Rapid Update 678

Grecale – Intercooler pipe replacement

DATE: DECEMBER 5 2023

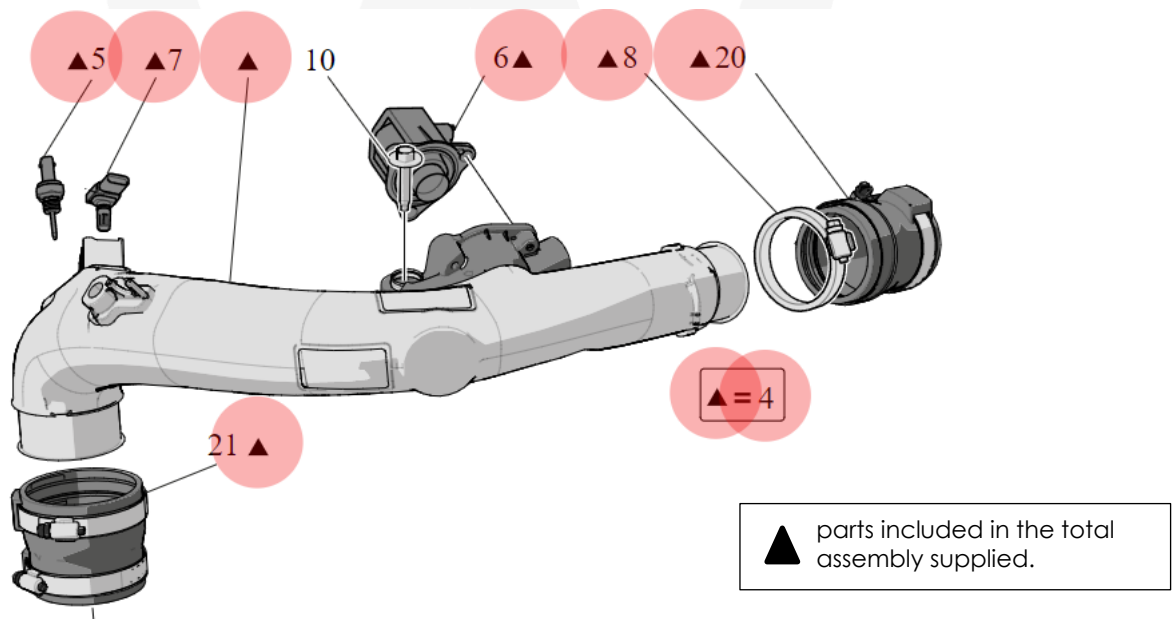
A limited batch of vehicles may potentially have been fitted with piping that has a plastic burr in the connection area. Over time, it can detach and cause noise and disruptions in the component's operation. The expectation of this anomaly occurring is very low and is usually detected early by triggering a MIL and setting a P2261 DTC. The procedure consists of replacing the non-compliant component.

5. Disconnect the oil vapor pipe: **Section 01.63 - 1**
01.50.187 - ENGINE OIL VAPOR SUCTION HOSE AT IDLE - Removal-Refitting or Replacement.
6. At this point, you can reach the outlet pipe of the turbocharger. replace the pipe following the workshop manual instructions. **Section 01.32 - 1**

Important! Parts highlighted in red are included with the new pipe. There is no need to transfer these parts from the old one.

01.40.062 AIR OUTLET PIPE FROM TURBOCHARGER TO MANIFOLD THROTTLE BODY - Removal-Refitting or Replacement
